ENDL TEXAS

Date: 25 June 2004
 To: T10 Technical Committee and SNIA OSD TWG
 From: Ralph O. Weber
 Subject: Rewrite of OSD Security and Policy/Storage Manager Models

Figure 1 — Example OSD Configuration

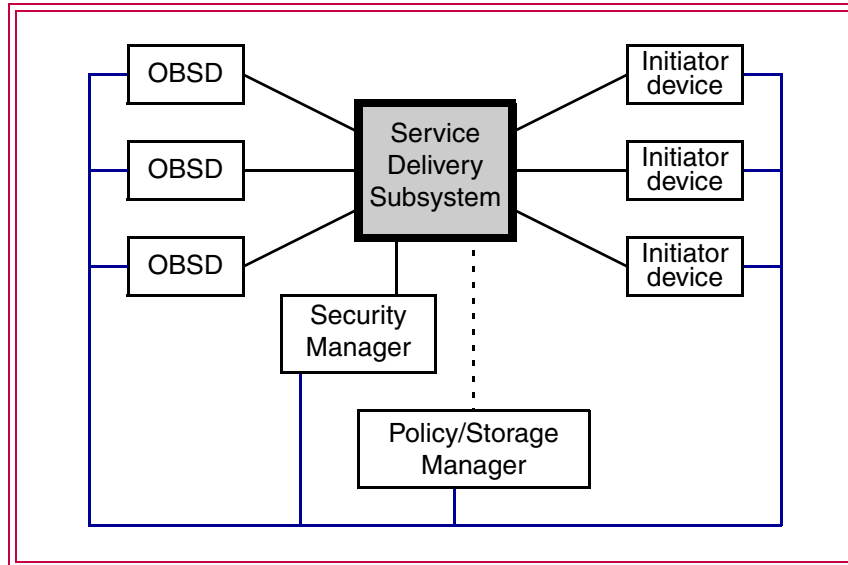
The security manager (see 4.9), if present, ~~coordinates access~~ secures capabilities in cryptographically protected credentials ~~between~~ for OSD device servers and application clients.

The ~~policy/storage manager and~~ security manager may reside in the OBSDs, in applications clients, or as a separate entities.

The ~~policy/storage manager and~~ security manager may use the service delivery subsystem and be an application client, but ~~they the security manager~~ also may use another mechanism to communicate with the OSD device servers and application clients. Security-related requirements on the communications mechanisms used by the security manager are described in 4.9.2
